Product Change Notification - SYST-13IXOV452

ERRATA - PIC32MK Motor Control and General Purpose Errata and Data Sheet Clarification

PIC32MK General Purpose and Motor Control (GP/MC) Silicon Errata and Data Sheet Clarification

FIGURE 1: POSC CRYSTAL CIRCUIT

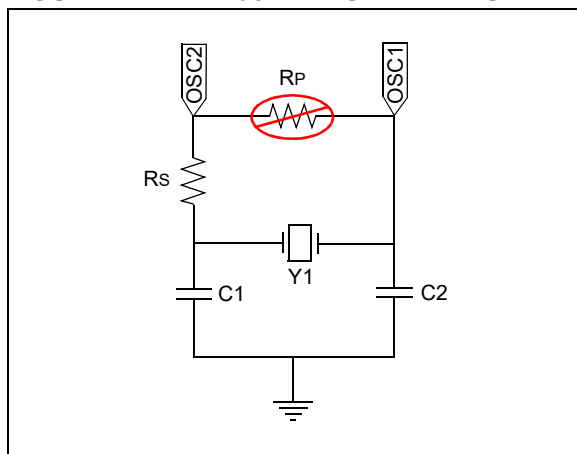
The POSC supports only specific crystal operation, as provided in [Table 1](#).

The Primary Oscillator (POSC) has been characterized to operate at 8 MHz and 12 MHz when the circuit shown in [Figure 1](#) is implemented and the operating conditions provided in [Table 1](#) are met.

Crystal Frequency (see Note 1)	Series Resistor Rs	Posc Gain Setting POSCGAIN<1:0> (DEVCFG0<20:19>)	Posc Boost Setting POSCBOOST (DEVCFG0<21>)
8 MHz	2 kΩ	'0b00 (GAIN_0)	'0b1
12 MHz	1 kΩ	'0b00 (GAIN_0)	'0b1
24 MHz ⁽³⁾	0	'0b00 (GAIN_0)	'0b1

FIGURE 2: RESET SUPERVISOR CIRCUIT

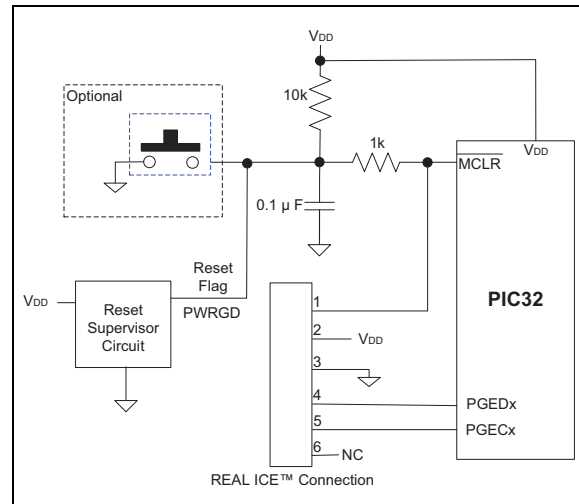
On a BOR event, $V_{POR} < V_{DD} < V_{BOR}$, a Reset is not generated when the BOR threshold is reached. System clocks will stop with all I/O pins functions frozen in their present state until either V_{DD} falls to V_{POR} or V_{DD} returns to above V_{BOR} . The user must assess if this V_{DD} brown-out condition and the resulting frozen I/O pin state has an adverse effect on their application (UART, PWM, I/O, OC, etc.).

Use an external Reset supervisor/monitor (see Figure 2). Some LDO regulators, as listed in Table 4, have an embedded reset supervisor included. The required minimum reset trip voltage of the supervisor should be at least $(V_{BOR} + 0.5V)$ with the SMCLR bit (DEVCFG0<15>) = 0 and the BORSEL bit (DEVCFG2<29>) = 1 in the Configuration Words. This means that the minimum V_{DD} operating voltage of the application needs to be above the reset supervisor maximum trip voltage at [Reset Trip (max) + 0.2V], (i.e. Application $V_{DD(MIN)} = \sim(V_{BOR} + 0.5V + 0.2V)$). The reset supervisor should have an open drain output so as not to interfere with the MPLAB

programming/debug tools. This workaround assures that MCLR will generate an internal POR and reset the I/O pins before the V_{BOR} trip point.
